**SERVICE INSTRUCTION no. 2013/01**  
**Increasing of efficiency of Paralite deflation system**

**With reference to:** Kubicek XR envelopes equipped by Paralite of serial numbers: 918, 962, 978, 983, 989, 993, 1010, 1016, 1022, 1024, 1025 and 1030.

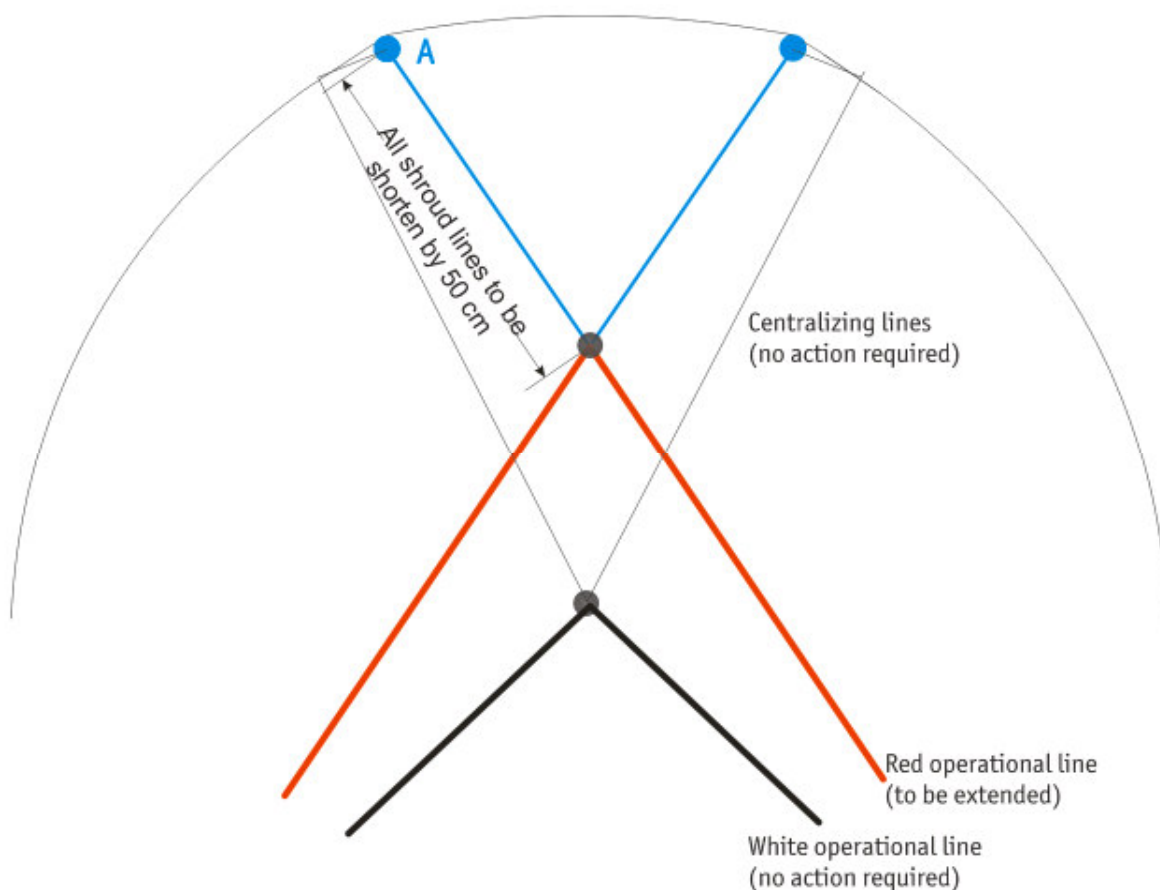
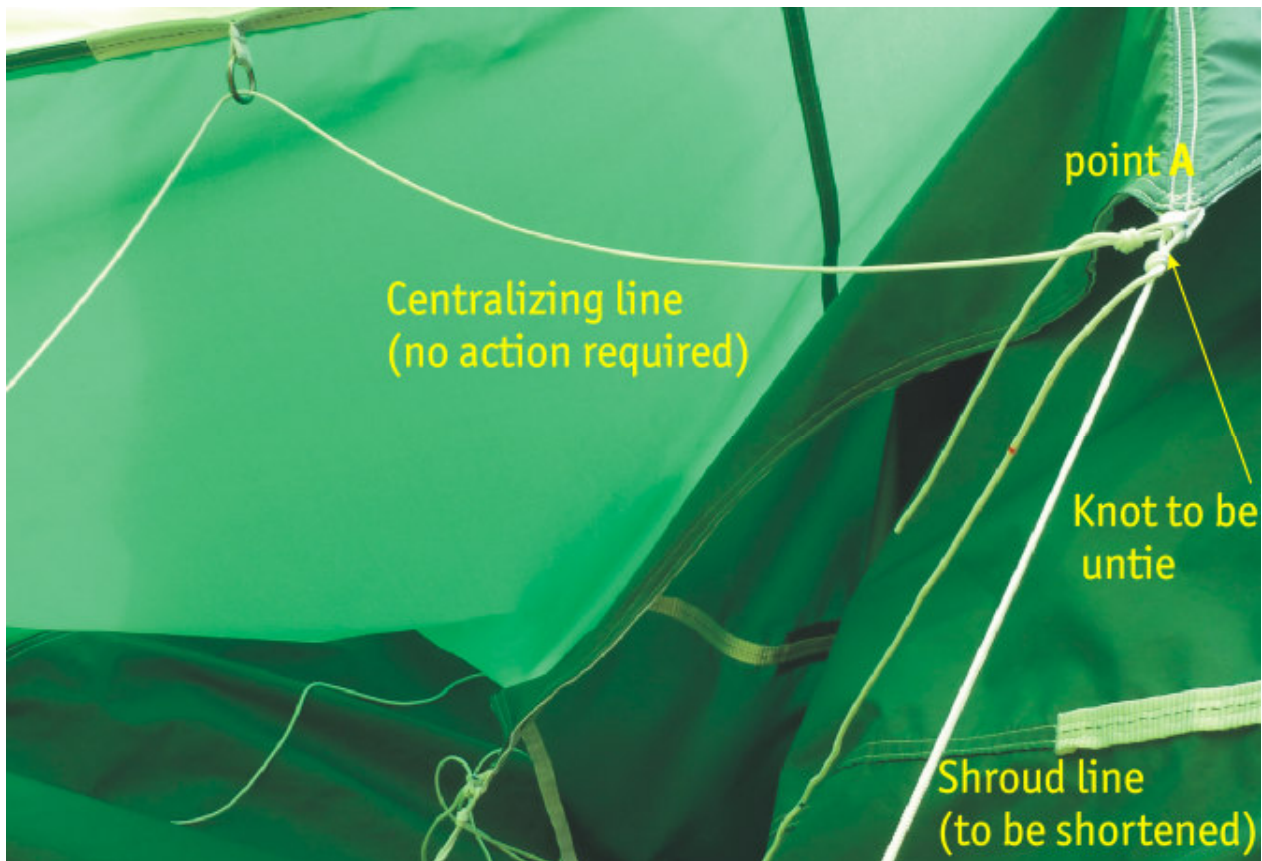
1. Shorten the shroud lines by 50 cm. Untie the line in point A (see the following picture and photo), cut the line by 50 cm and tie it again
2. Extend the red operational line by 1.5m (BB20XR) and 1.5 m (BB22XR, BB26XR, BB30XR). Use the reserve inside the envelope. If the reserve is not long enough a new operation line must be fitted in.
3. Perform a test inflation according to Maintenance Manual B.2202 (B.2205 for US registered balloons) 7.19.4
